**No. EC155-31-028**

# SERVICE BULLETIN

### INDICATING AND RECORDING SYSTEMS - Display system Mixability of Smart Multifunction Display (SMD) screen 45

Related to modification 0731C06

Figure 1

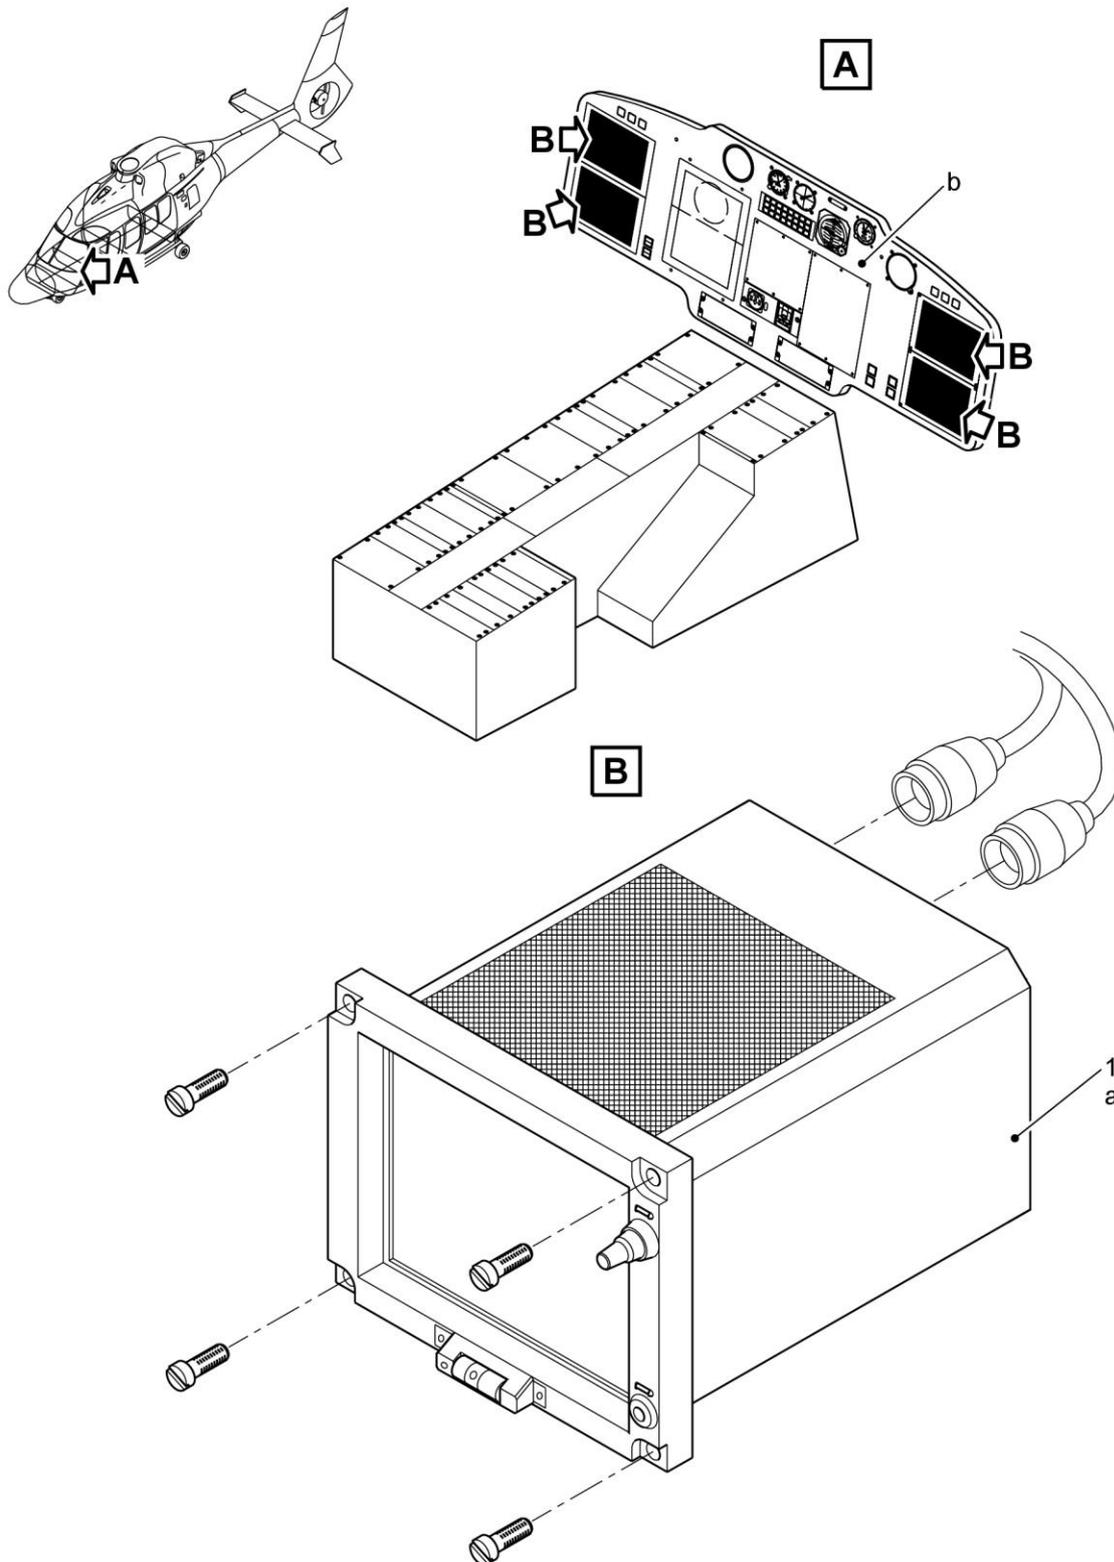
#### 3.B.2.a. Removal and sending of SMD 45 non-NVG ([Figure 1](#))

- Remove SMD 45 non-NVG (a) MP/N: C19209VG11 (P/N: 704A45751182) from the front panel (b). Refer to Task 34-70-01-061 (AMM).
- Send SMD 45 non-NVG (a) MP/N: C19209VG11 (P/N: 704A45751182) back to the manufacturer. Refer to paragraph [2.D](#).

#### 3.B.2.b. Receipt and installation of SMD 45 NVG ([Figure 1](#))

- Make sure that the part number of SMD 45 NVG (1) sent back by the manufacturer is: MP/N: C19267VG11 (P/N: 704A45751184).
- Install and do the configuration of SMD 45 NVG (1) MP/N: C19267VG11 (P/N: 704A45751184) on the front panel (b). Refer to Task 34-70-01-061 (AMM).
